HISTORIC AND DESIGN REVIEW COMMISSION

HDRC CASE NO: 2023-218
ADDRESS: 719 E CARSON
LEGAL DESCRIPTION: NCB 1261 BLK 29 LOT 19, 20 & S 9.8 FT OF 18
ZONING: R-6, H
CITY COUNCIL DIST.: 2
DISTRICT: Government Hill Historic District
APPLICANT: Eugene Walker Jr./EVENT HOLDINGS LLC
OWNER: Eugene Walker Jr./EVENT HOLDINGS LLC
TYPE OF WORK: Addition (turret)
APPLICATION RECEIVED: May 18, 2023
60-DAY REVIEW: July 17, 2023
CASE MANAGER: Jessica Anderson

The applicant requests a Certificate of Appropriateness for approval to add a turret at the southeast corner of the house.

Historic and Design Review Commission
Design Review Committee Report

TURRET PLAN- NTS

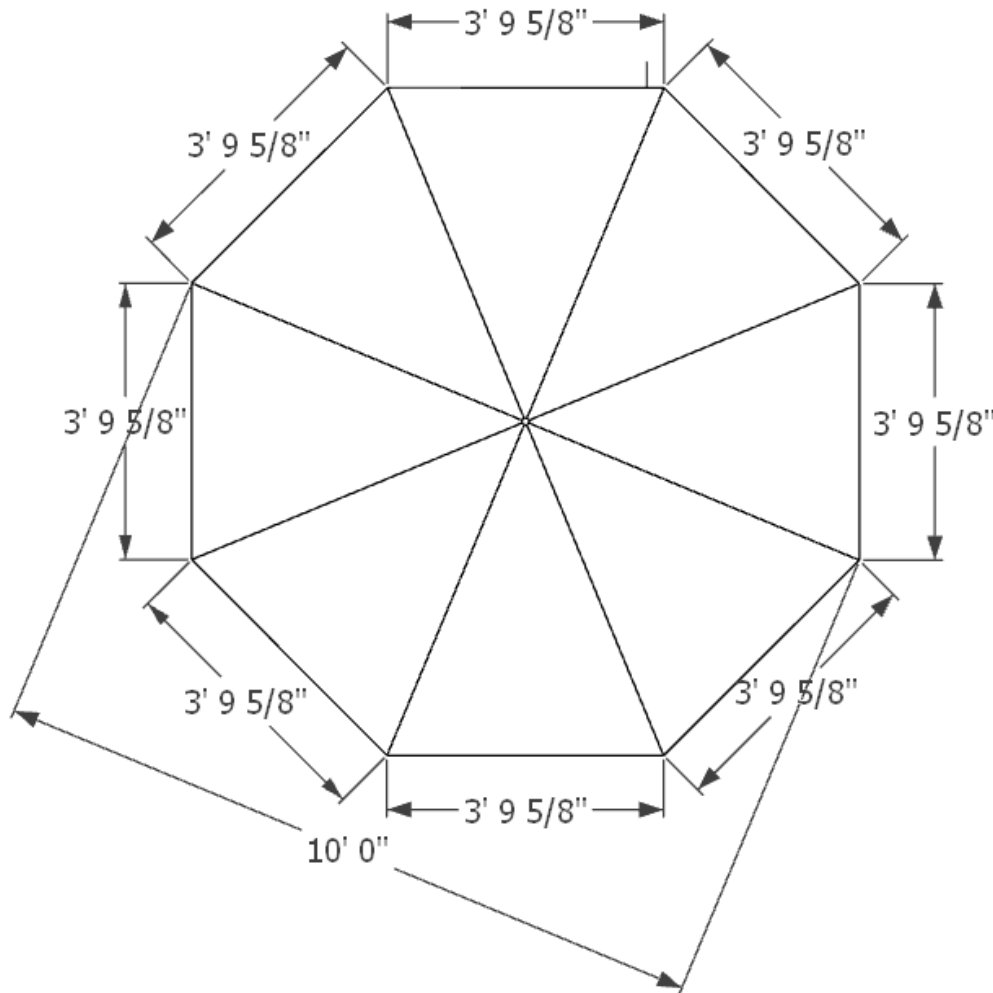
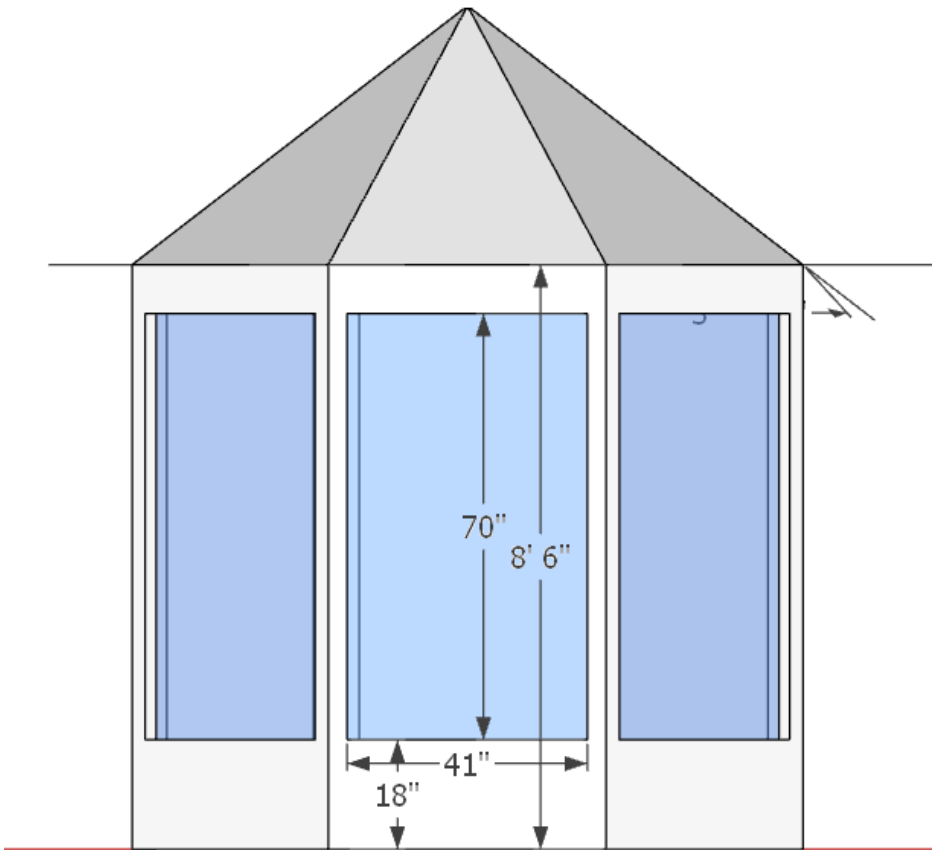
- d. TURRET: The applicant requests approval to add a turret at the southeast corner of the house. Historic Design Guidelines for Additions 1.B.ii says to ensure dormers are compatible in size, scale, proportion, placement, and detail with the style of the house. While staff finds the turret generally appropriate, the new Jeld-Wen clad wood windows proposed for the addition should match the second-story windows directly below the addition in width.

- i. That the windows proposed for the addition match the second-story windows directly below the addition in width.
- ii. That the proposed windows feature meeting rails that are no taller than 1.25" and stiles no wider than 2.25".
- iii. That the turret roof be clad in the same material as the primary roof form.

Savino: Other concern I had from the beginning is the way the turret intersects the eyebrow vent.

Savino: That even makes it more important that it's visible. Concerned about that. I would venture to say that turret was not a tall turret.

Savino: I agree. The turret is awkward in size relative to the rest of the house. I think what Roland is observing is correct.

Commissioners are concerned about treatment of the eyebrow dormer. Commissioners believe evidence on site points to the form being an octagonal roof only. Existing turret is awkward in size. When front chimney is rebuilt, should be built to reflect its prominent location and incorporate details found on other two existing chimneys.
